MODEL AFFECTED: 205B

SUBJECT: UPPER CREW DOOR HINGE STRUCTURE,
REINFORCEMENT OF.

HELICOPTERS AFFECTED: All model 205B helicopters.

Figure 1 (Sheet 1 of 2)

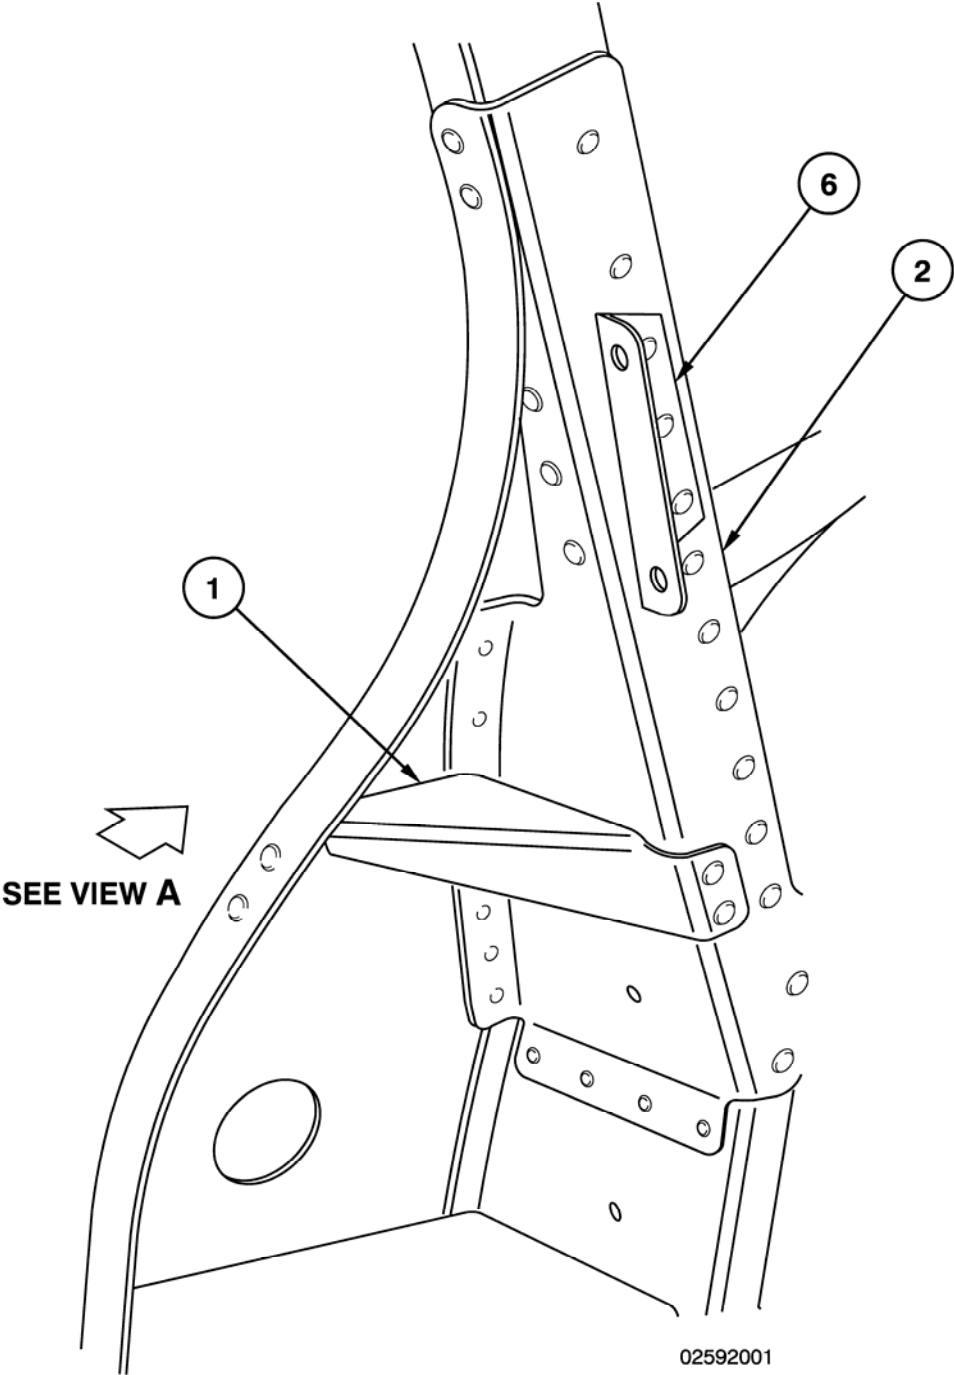
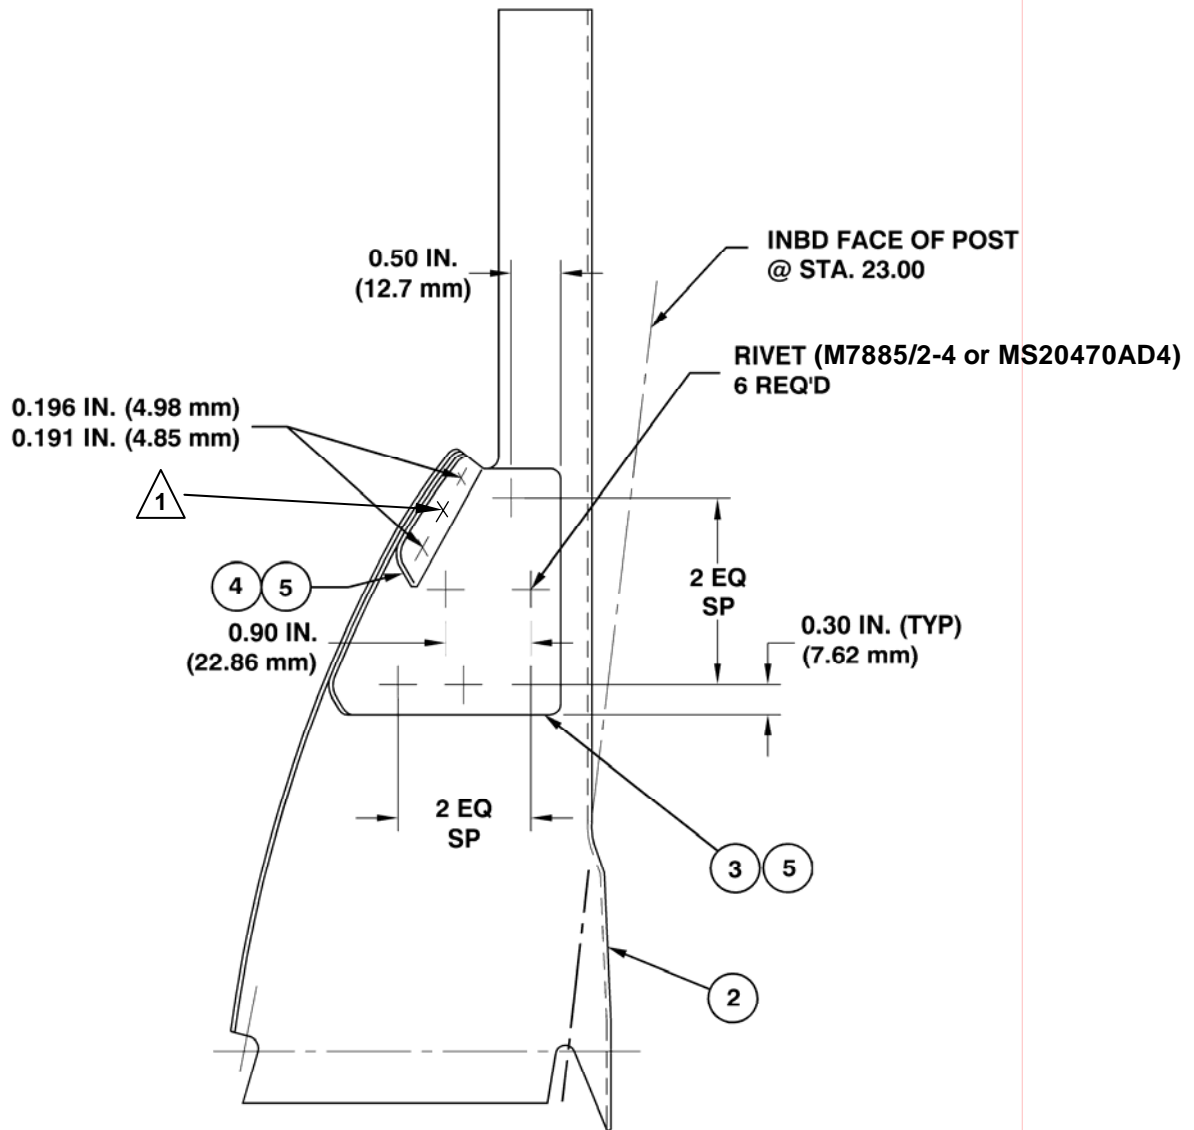
Bell Helicopter has received some reports of cracking occurring at supports P/N 204-030-662-013 & -014 caused by the crew doors repeatedly hitting their open stop, especially under windy conditions. This bulletin provides the instructions for a simple reinforcement to the surrounding area.

5. On left side, remove instrument panel support fitting (6).
6. Remove support (1) and support (2) as a unit. Remove support (1) from support (2).
7. Fit doubler (3) and radius block (4); refer to View A. See note 1 in Figure 1. Verify for possible interference with support (1) and trim doubler as required. Trim radius block to follow edge of doubler (3) and support (2). Secure with Cleco fasteners.

1. Existing support (ref.)
 2. Existing support (ref.)
 3. Doubler LH (204-030-662-119)
Doubler RH (204-030-662-120)
 4. Radius Block (20-042-8-14)
 5. Adhesive (299-947-100 Type II, Class 2)
 6. Existing fitting (ref.)
- △ 1 Existing rivet hole, countersink this hole in doubler (3), dimple in support (2), if replaced

Figure 2

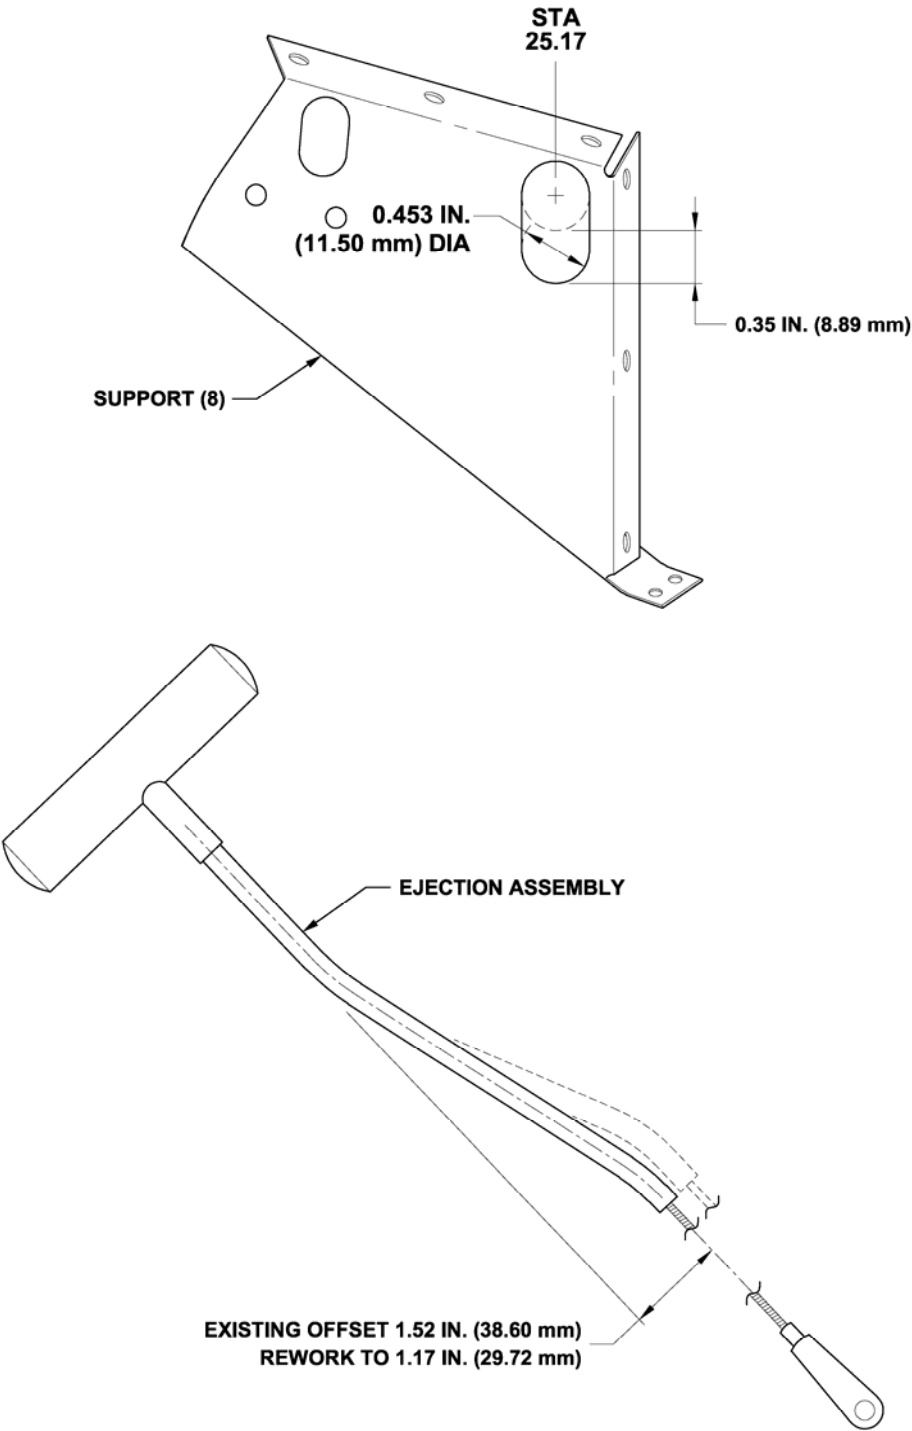
8. Rework existing support (1) as per Figure 2 or fit new support.
9. Remove supports (1 and 2), doubler (3), radius block (4) and deburr.
10. Apply adhesive (C-317) to doubler (3) and radius block (4) and install using M7885/2-4 rivets (or MS20470AD4 rivets). Remove excess adhesive.

14. Rework existing ejection assy as per Figure 2 or replace with new ejection assy. Re-install door-jettisoning mechanism.
